November 7, 2023

RE: Draft Mojave Desert Tortoise Strategic Plan and Rangewide Mojave Desert Tortoise Action

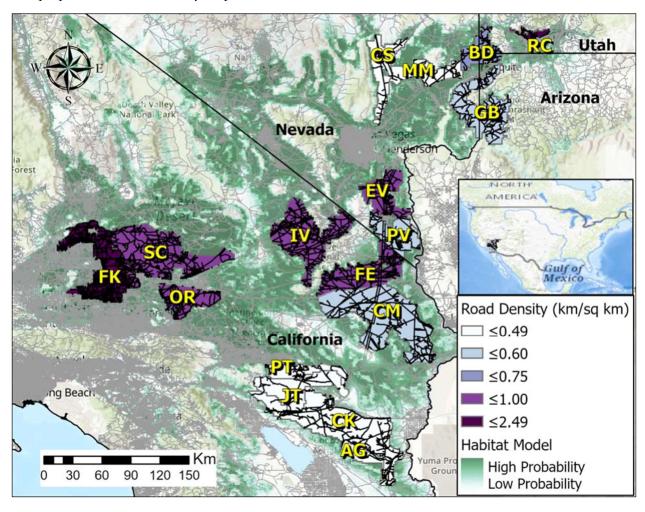
More generally, Averill-Murray and Allison (2023) found that all BLM resource management plans throughout the range of the MDT failed to account for road and trail density, and that populations declined within all conservation areas with road densities greater than 0.75 km/km<sup>2</sup>. They calculated

road (paved, maintained and unmaintained dirt) density<sup>11</sup> within desert tortoise critical habitat units and prepared the route density map, below.

Road density was highest in the Fremont-Kramer CHU at 1.57 km/km², with the Superior-Cronese, Ord-Rodman, Ivanpah Valley, Fenner and Eldorado Valley at 1.0/km², all exceeding the recommended maximum density of 0.6 km/km². Averill-Murray and Allison recommended that road densities of less than 0.6 km/km² may be necessary in areas with particularly sensitive, declining or threatened species, such as the MDT.

We also recommend that BLM apply the findings of Averill-Murray and Allison in each of the project areas and specify actions that will be taken to achieve a density of less than 0.6 km/km² of roads and OHV routes in all areas where MDT densities are declining and below minimum viable density.
